Subject: Summary of June 10, 2010 follow-up phone call with Summer to discuss hydrology
Sent Date: 6/16/2010 2:48:06 PM
Received Date: 6/16/2010 2:48:06 PM
From: Wentzel, Michael

Subject: Virgil C. Summer Nuclear Station (VCSNS) Units 2 and 3 Combined
License Application (COLA) - Docket Numbers 52-027 and 52-028
Supplemental Response No. 2 to NRC Request for Additional
Information (RAI) Letter No.041 Related to Groundwater

NRC RAI Number: 02.04.12-6

RAI Figure 2.4.12-6: Ground Cover Layout between 394' Elevation Contours

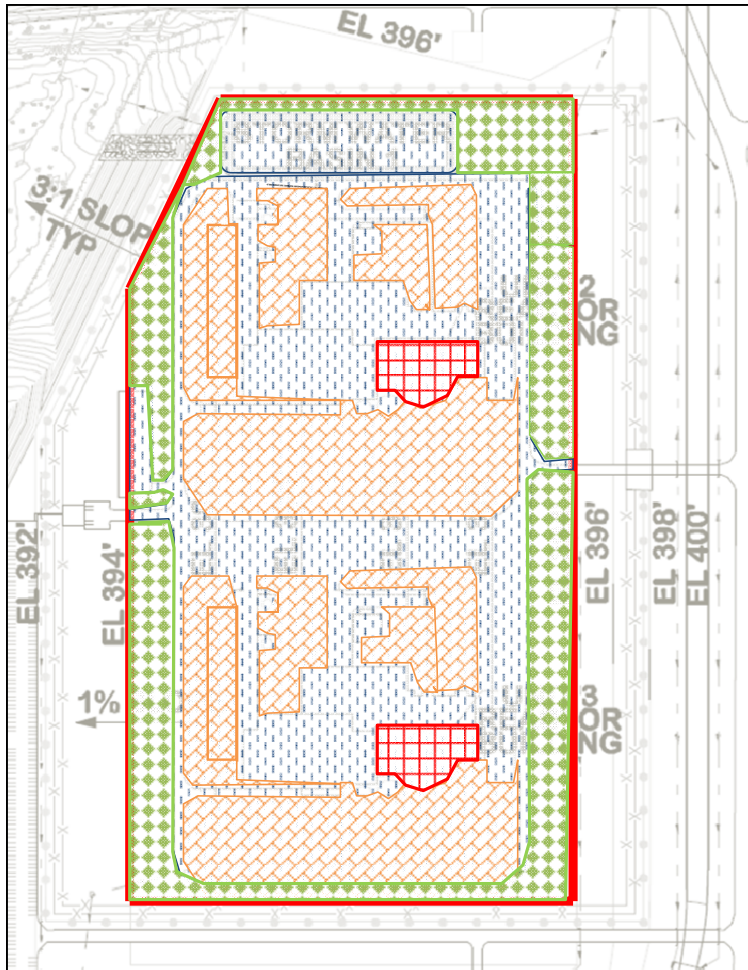
3) Areal distribution of post construction surface features above the 394' elevation contour. A map or GIS coverage identifying areas of pavement; grass; gravel; concrete pads; structures; whatever other surface features are envisioned.

During the phone call, SCE&G agreed to provide an estimate of permeable vs impermeable land cover on the Summer 2&3 site based on FSAR Figure 2.5.4-245. This would facilitate the confirmatory calculations that must be performed as part of the staff's review and should address agenda items 1-3. The NRC expressed the desire for this information to be included in the FSAR.

10 CFR52.79(d)(2) requires that the FSAR demonstrate that the interface requirements established under 10CFR52.47 (site parameters) have been met and to show compliance with 10CFR 100.20(c), which requires consideration of the physical characteristics of the site. The staff requests that the applicant describe the impact of the post-construction / operational setting on water table elevations (site grading including infilling on east below cooling towers, removal of saprolite/shallow bedrock zone, hydraulic properties and use of common fill and structural fill, changes in surface recharge) and subsurface pathways. This would include descriptions of changes in site grading, land cover, recharge rates, and fill material properties.

The ground cover following construction is expected to contain a relatively large amount of impervious cover within the immediate plant area. For the purpose of this evaluation, the immediate plant area is defined as the area inside of the following relative to True North:

- 394' contours that run approximately North-South on either side of the proposed units as shown on VCSNS FSAR Figure 2.5.4-245.
- The innermost fence shown running East-West on the North side of Unit 2 and South side of Unit 3 as shown of VCSNS FSAR Figure 2.5.4-245.

As defined above, the immediate plant area contains approximately 42.5 acres. Included in that area is approximately 17 acres of impervious ground cover (1.5 acres of nuclear island structures founded on hard rock, 4 acres of power block structures whose foundations are located on engineered backfill, and the remaining 11.5 acres are of buildings and paved areas throughout the immediate plant area), approximately 15 acres of surface area assumed to be covered in compacted gravel or otherwise hardscaped to promote run off, and approximately 10.5 acres of grass serving as an outer most border (see attached Figure RAI 2.4.12-6). This combination of ground cover will shed much of the stormwater runoff to the closed Storm Drain System (DRS) for transportation away from the immediate plant area. Thus, the opportunity for infiltration recharge to increase groundwater levels in the plant area is expected to be reduced.

Operating experience at VC Summer Unit 1 has shown that vegetative areas near plants has unintended drawbacks such as welcoming wildlife that creates housekeeping concerns. It is expected that the surface areas covered in vegetation near the proposed units will be minimized for miscellaneous reasons. Therefore, the amount of impervious or compacted gravel/hardscaped ground cover may be even higher than that estimated above.
